WATER QUALITY MEMORANDUM

Utah Coal Regulatory Program

SUBJECT: 2010 3rd Quarter Water Monitoring: Bear Canyon Mine, C/015/0025,
Task ID # 3621

Alkalinity Levels in Selected Spring Samples

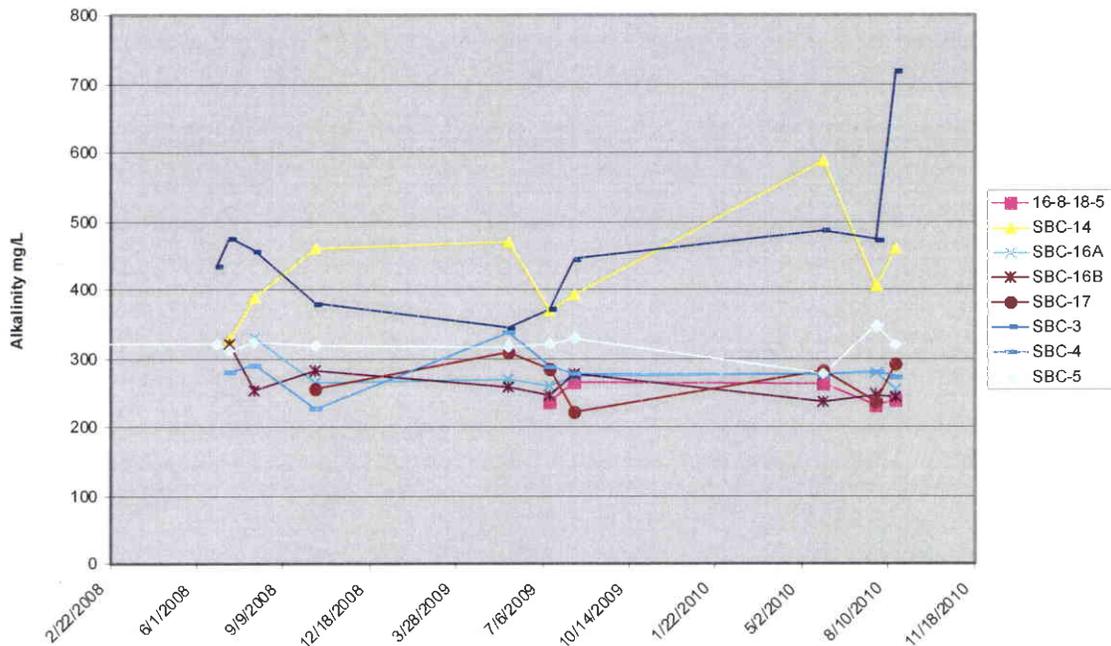
As can be seen in the chart above, alkalinity concentrations have shown a sharp increase in samples SBC-14 and SBC-3. Continued monitoring is recommended to see if an upward trend is observable.

o Alkalinity concentrations have shown a sharp increase in samples SBC-14 and SBC-3. Continued monitoring is recommended to see if an upward trend is observable.
